Ref. No.201504020
Petition No. 403

REQUEST BERM USE
 (For Parking Only)
 INTO STRATHMOOR AVE.
 AT 14501 W. 8 MILE RD.

CITY OF DETROIT CITY ENGINEERING DEPARTMENT	
SURVEY BUREAU	
JOB NO.	01-01
DRWG. NO.	X 403

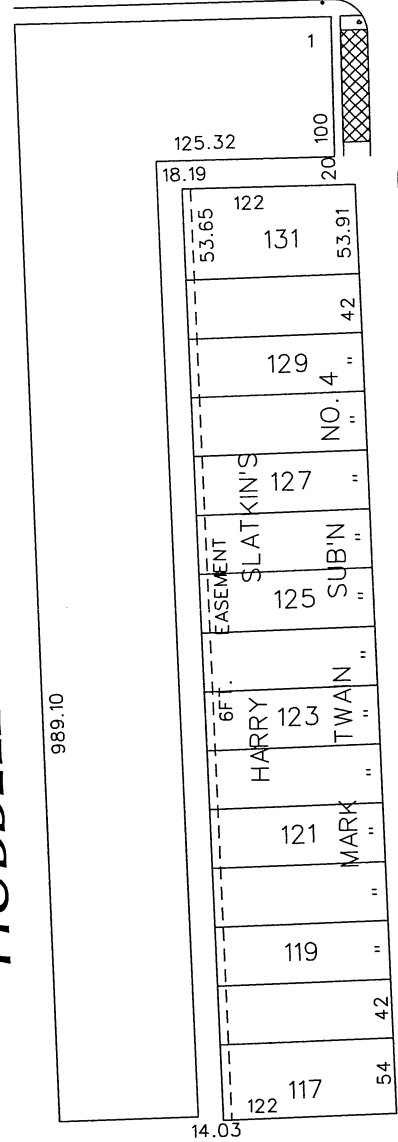
- () Involved; the nature of our services, and the estimated costs of removing and/or rerouting such services are:
- (x) Involved; The request for berm use (for parking only) into Strathmoor Avenue at 14501 W. Eight Mile Road as outlined in petition # 403 as shown on drawing no. x403 dated 4-8-2015 is approved provided that the following conditions are met with:

1. Requestor shall be responsible, at his/her expense, to install/ maintain continuous concrete stoppers for separation of vehicular and pedestrian usage as shown on the attached typical drawing by Traffic Engineering Division dated 05/13/2009 showing the layout of the berm parking.

2. Requestor shall be responsible, at his/her expense, to construct/modify the berm surface as per City standards. Requestor shall be responsible to remove curb along the edge of the berm parking to allow for entry/exit. Requestor shall be responsible for maintaining the berm surface and removal of snow from the berm area, at his/her expense.

3. The requestor shall be responsible, at his/her expense, to install/maintain parking control signs and pavement markings associated with the berm parking as per City standards.

6. This request is approved **only for parallel parking**. On street parking along the stretch adjacent to the berm parking will not be permitted
